## **2.5 Geology, Seismology, and Geotechnical Engineering**

**Figure 2.5.2-7 Four mean seismic hazard curves (1 Hz, 2.5 Hz, 5 Hz, and 10 Hz) for EGC ESP site plotted on a log-log scale. Dashed lines indicate annual probability of exceedance intervals of  $10^{-4}$  per year and  $10^{-5}$  per year.**

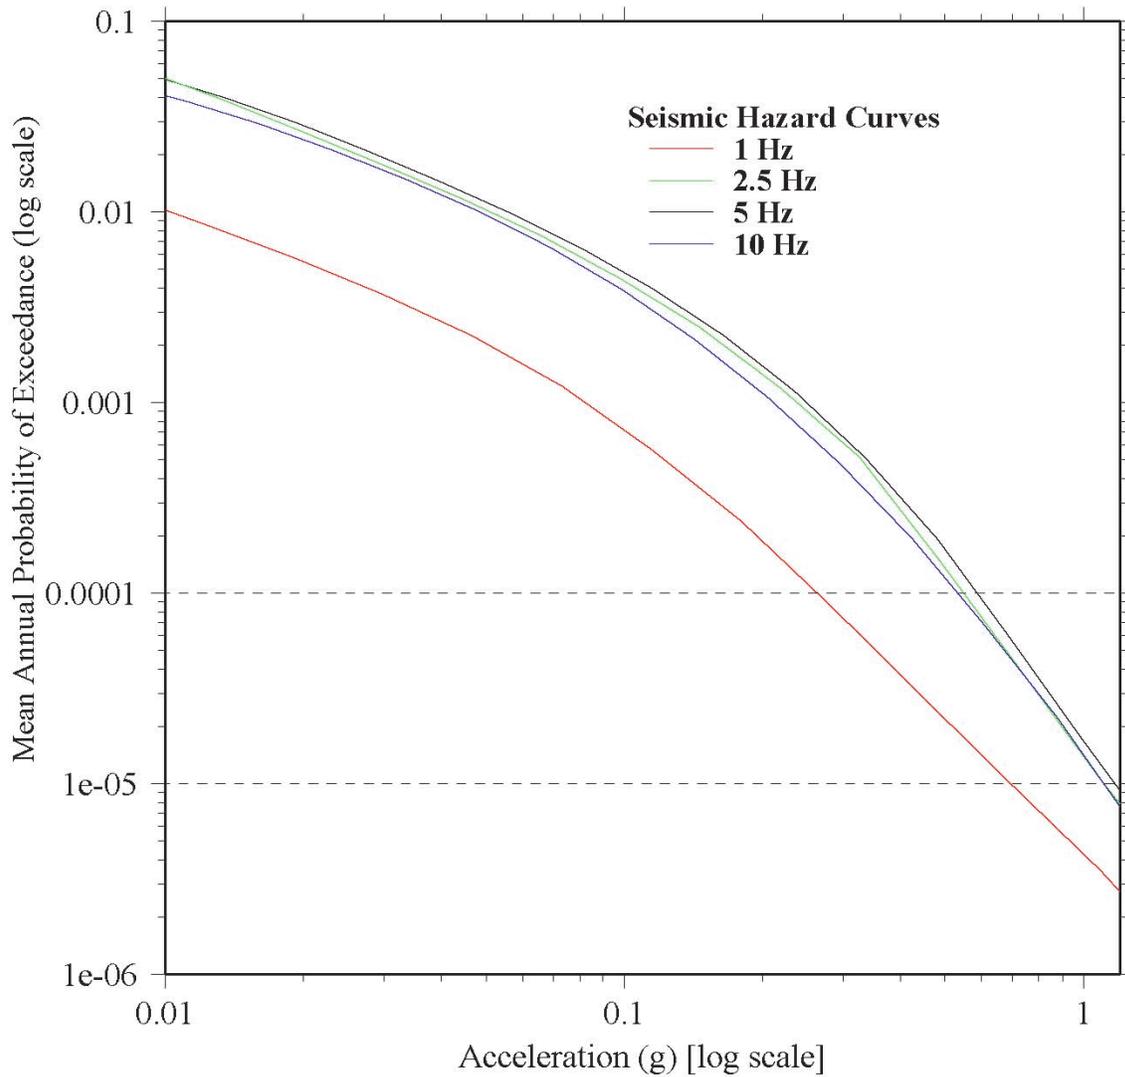
Linear Hazard Equation. In Open Item 2.5.2-5(a), the staff asked the applicant to justify the assumption of a linear hazard curve in logarithmic space (see Equation 2.5.2-13 and Figure 2.5.2-7) and the appropriateness of solely using the  $10^{-4}$  to  $10^{-5}$  interval to determine the amplitude ratio  $A_R$  and, as such, the DF. In response, the applicant stated the following:

Since the seismic hazard curves have a slight downward curvature, as illustrated in Figure 2.5.2-7, assuming a linear fit results in slightly higher exceedance values and, as a result, slightly higher SSE values, as illustrated above in Table 2.5.2-4. Therefore, the staff concludes that the applicant’s use of the approximate power law hazard curve is slightly conservative and therefore acceptable.

**Figure 2.5.2-12 EGC ESP 5-Hz mean seismic hazard curve and seismic fragility curve in terms of the lognormal PDF**

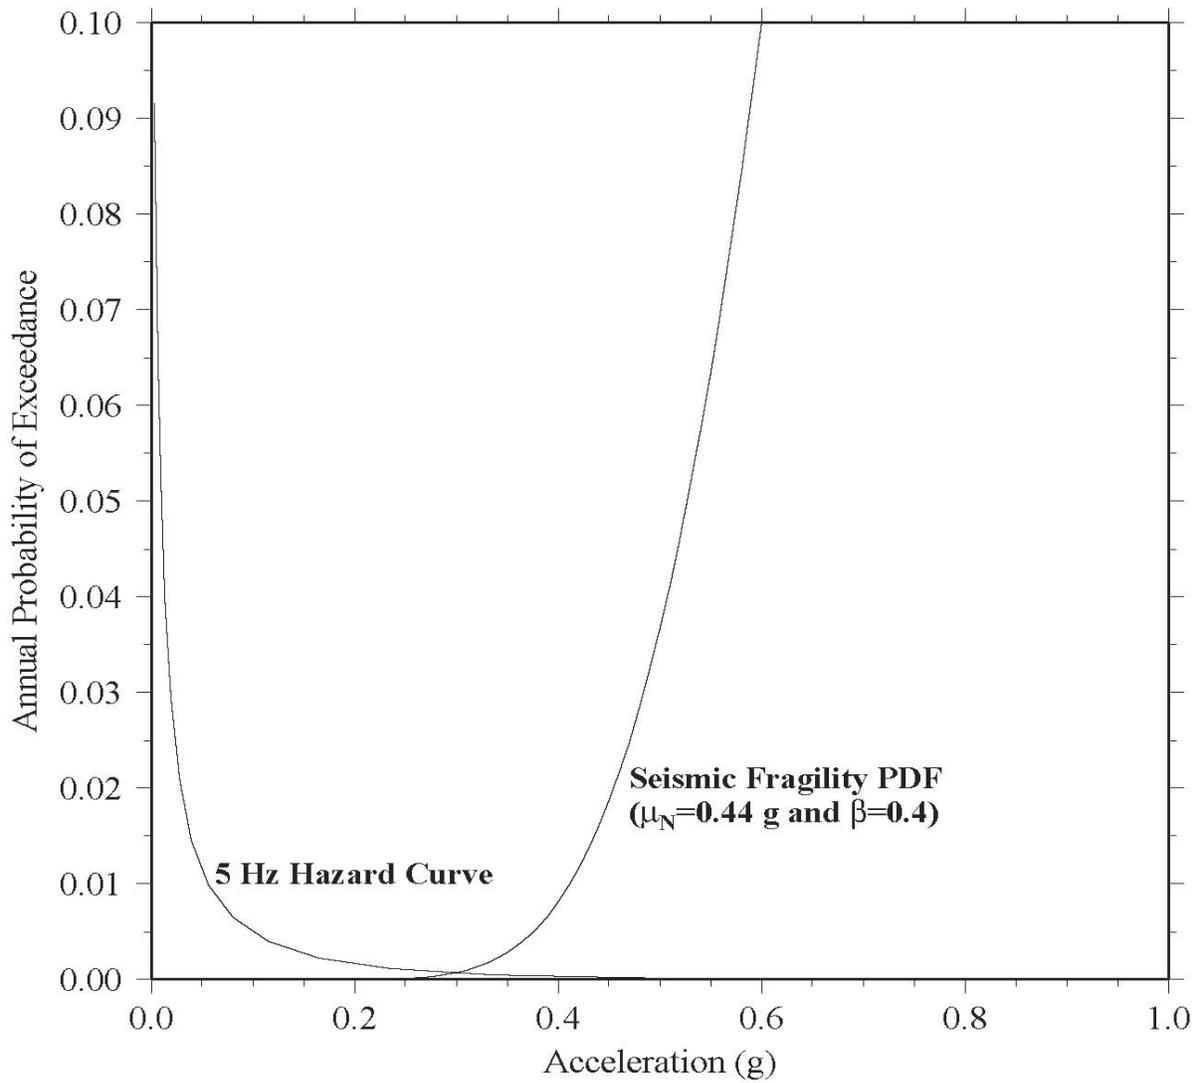
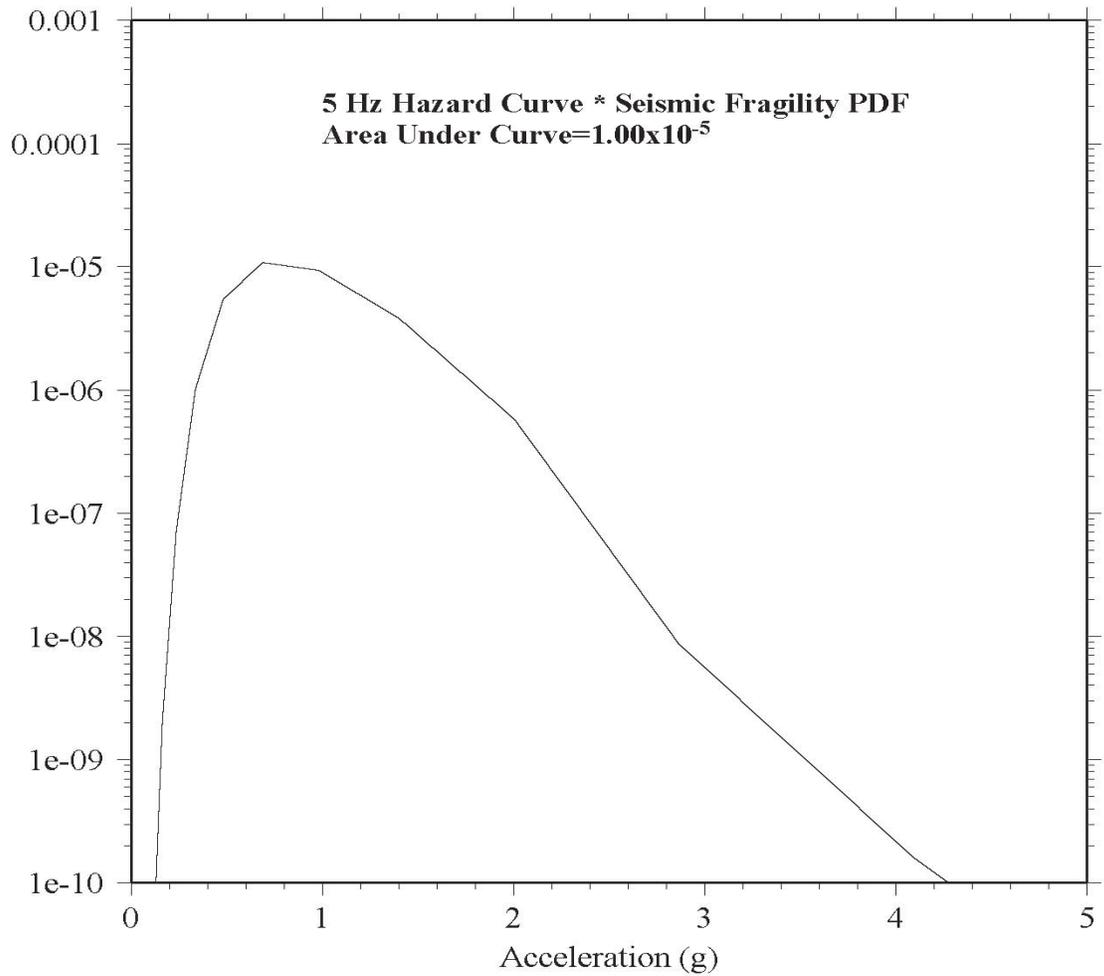
Substituting this expression for the fragility PDF into the risk integral (Equation 2.5.2-9) enables the determination of the SSE value that achieves the target performance goal of  $10^{-5}$ . Figure 2.5.2-12 shows the EGC ESP seismic hazard curve for a natural frequency of 5 Hz along with the seismic fragility PDF, assuming specific values for the SSE, seismic margin ( $M_s$ ), and standard deviation ( $\beta$ ). Figure 2.5.2-13 shows the product of the seismic hazard and fragility curves. The spectral acceleration value that gives an area of  $10^{-5}$  under the curve in Figure 2.5.2-13 is the value of the SSE for the natural frequency of 5 Hz.

Figure 2.5.2-14 Comparison of exact and approximate  $DF$ . Exact  $DF$  varies with both  $A_R$  and  $\beta$ , while approximate  $DF$  depends only on  $A_R$ .

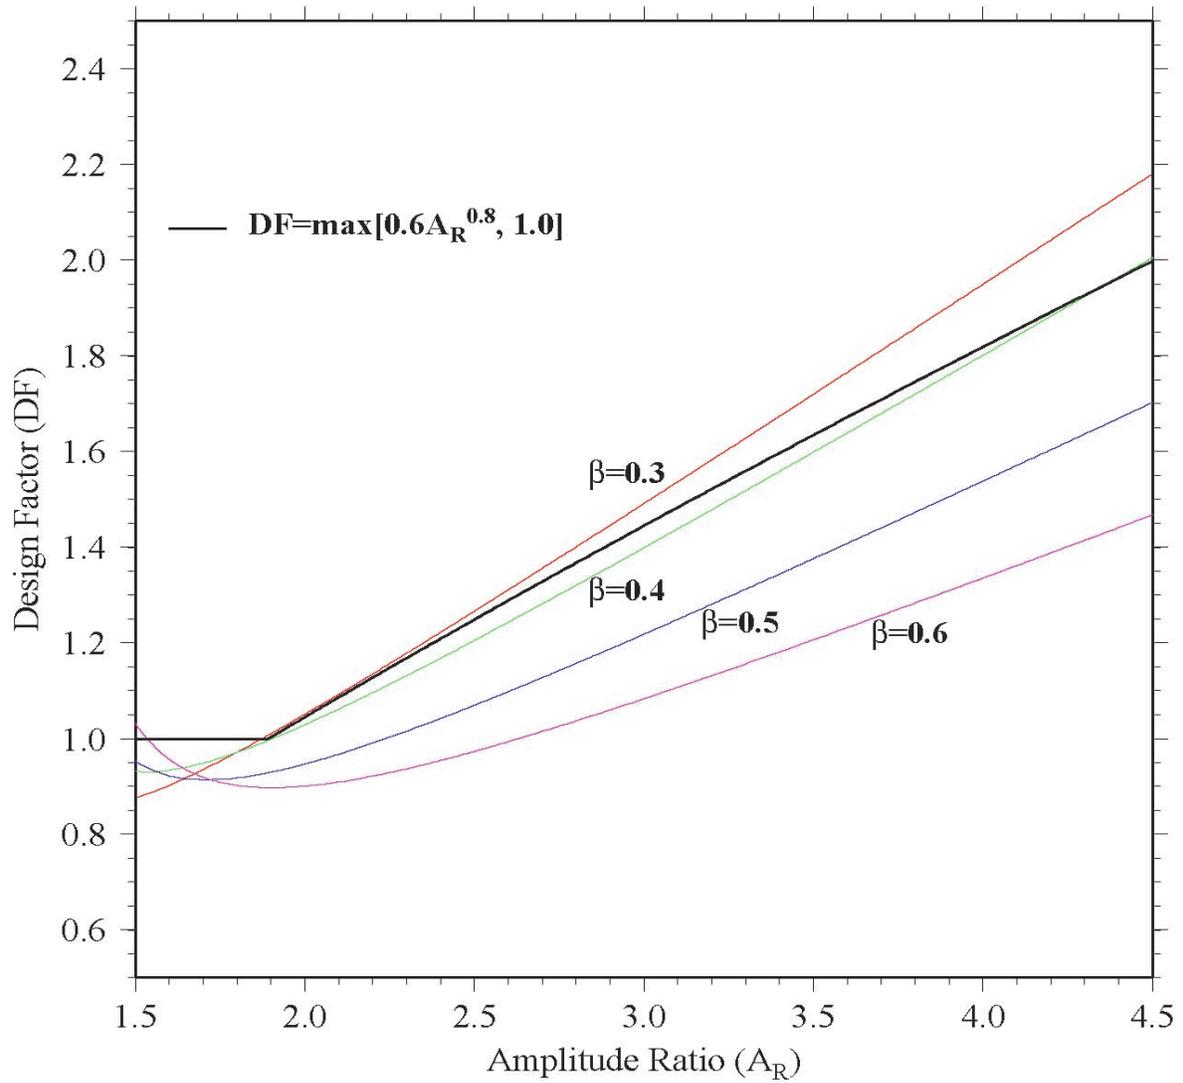
As shown previously in Figure 2.5.2-14 in Section 2.5.2.1.6.1, the DF recommended in ASCE/SEI 43-05 (Equation 2.5.2-1) is slightly unconservative for  $\beta=0.3$  and conservative for larger  $\beta$  of 0.4 to 0.6. To evaluate the significance of the range of  $\beta$  values on the DF, the staff determined the unacceptable performance frequency values ( $P_{FT}$ ) for the performance-based SSE values for four natural frequency values 1, 2.5, 5, and 10 Hz. The applicant determined the four performance-based SSE values shown below in Table 2.5.2-5 using the performance-based approach as described in ASCE/SEI 43-05, which assumes a  $\beta$  value of 0.4 and a target performance goal of  $1 \times 10^{-5}/\text{yr}$ . The staff used the four hazard curves provided by the applicant to determine  $P_{FT}$  via direct integration of the risk integral (Equation 2.5.2-9) for  $\beta$  ranging from 0.3 to 0.6. As shown below in Table 2.5.2-5, the  $P_{FT}$  values for  $\beta=0.3$  are only slightly larger than the target value of  $1 \times 10^{-5}/\text{yr}$ .

**Figure 2.5.2-17 Seismic core damage in terms of mean ground motion recurrence interval for EGC ESP site and 25 nuclear power plants. For comparison, FOSID is also shown.**

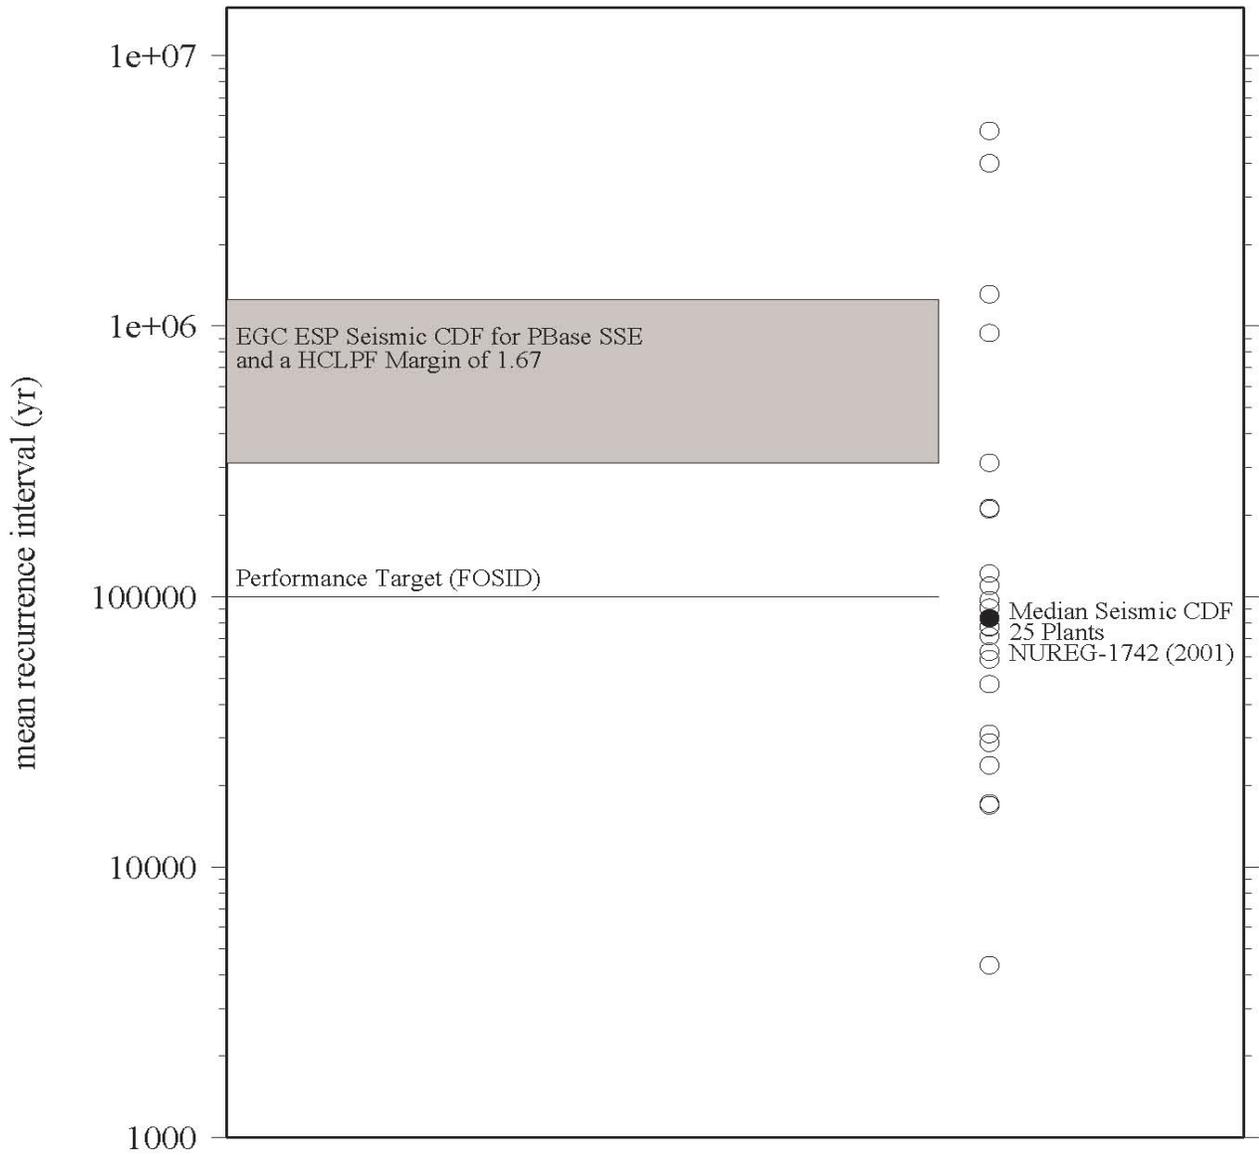
In conclusion, the staff has determined that there is a significant difference between OSID, which is set at  $10^{-5}/\text{yr}$  as the target performance goal, and seismic core damage. This result follows from assuming that the seismic margin against core damage is 1.67 as specified in SRM, dated July 21, 1993, on SECY 93-087.

**Figure 2.5.4-3 Material damping plot resonant column and cyclic torsion test results**

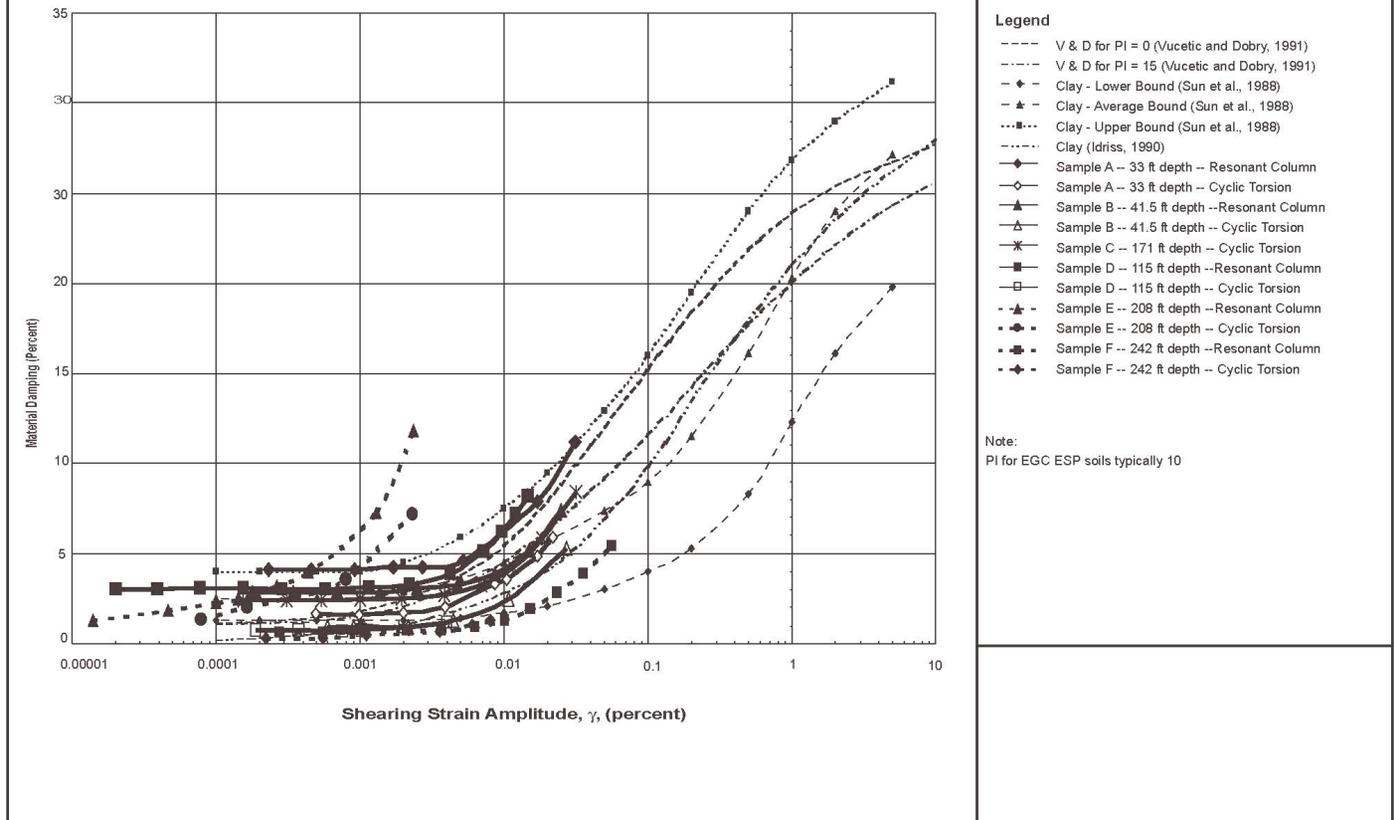
In RAI 2.5.4-2, the staff asked the applicant to justify its use of the EPRI curves and to further explain its basis for concluding that the ESP site soils are consistent with those used to develop the EPRI curves. In response to RAI 2.5.4-2, the applicant stated that the EPRI curves it used represent soils in the general range of gravelly sands to low-plasticity silty or sandy clays and that soils at the ESP site fall within this category of soils. SER Section 2.5.4.3.2 provides a complete description of the applicant's response to RAI 2.5.4-2 and the staff's evaluation of this response.

The information in Figure 5-21 (SSAR Appendix A) does indeed suggest that the hysteric damping from the laboratory tests was higher than the EPRI curves.

The same conclusion can be made from the information in Figure 5-24. However, the curves that are above the EPRI damping curves are related to the resonant column tests. The fact that the resonant column data shown in Figures 5-21 and 5-24 are solid, bold lines masks the response from the torsional shear tests—suggesting that all the damping values are too high at low shearing strain amplitudes. However, material damping values from the torsional shear tests are consistent with the EPRI damping curves, as shown in Figures 4.2-2 through 4.2-6 of Appendix B to the EGC ESP SSAR.

**Figure 2.5.4-6 Modulus reduction and damping test results compared to EPRI (1993) soil property curves for test UTA-34-A**

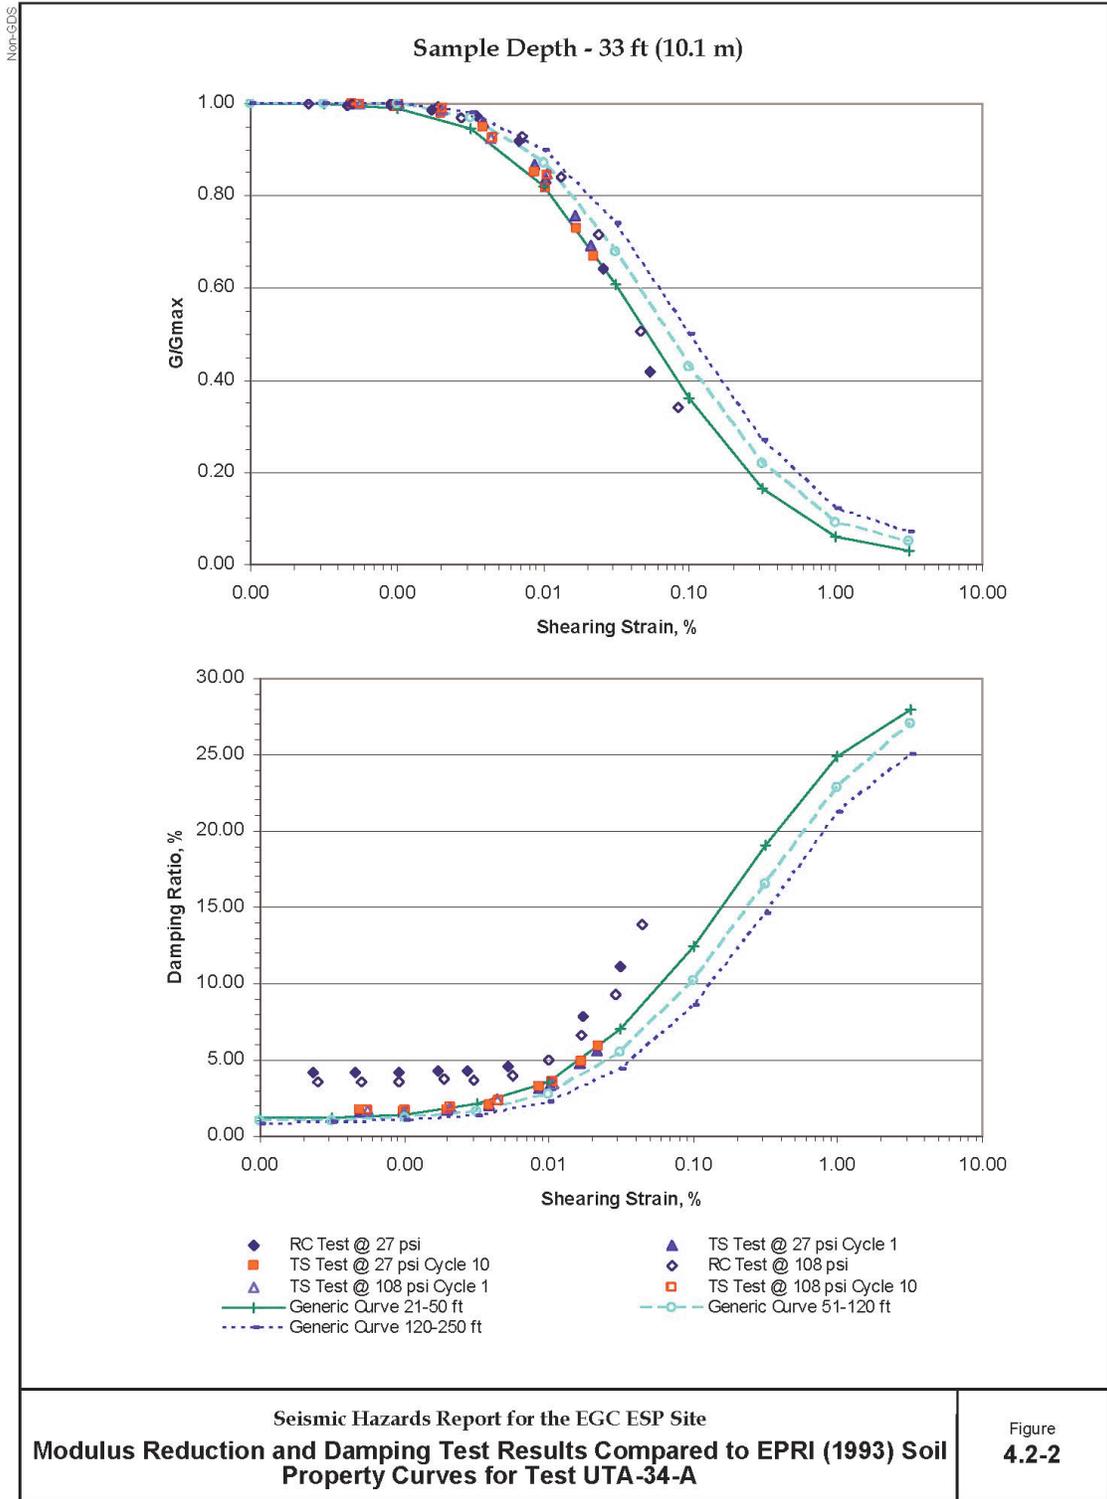
In order to verify the applicant's classification of the ESP soils as "gravelly sands to low plasticity silty and sandy clays," the staff reviewed Section 5.2.2 of SSAR Appendix A. Section 5.2.2 provides a general description of each of the soil layers underlying the ESP site and includes information on plasticity, water content, and dry density. The staff concludes from its review that the applicant's characterization of the ESP site soils is appropriate. In addition, the staff concludes that the applicant's use of the EPRI curves is justified since these curves are based on a much larger database of properties from similar soils (gravelly sands) than those obtained by the applicant for the ESP site from its four soil borings. Although the fit between the EPRI curves and the resonant column tests on the ESP site soils is weak, the staff notes that the torsional shear test data do fit the EPRI curves. The frequency of loading for the torsional shear tests ranges from 0.1 to 10 Hz, which is consistent with the predominant frequencies of earthquake ground motion. Figure 2.5.4-6, which reproduces Figure 4.2-2 from

SSAR Appendix B, shows the fit between the ESP site data from the resonant column and torsional shear tests compared to the EPRI (1993) generic curves for gravelly sands to low-plasticity silty or sand clays.
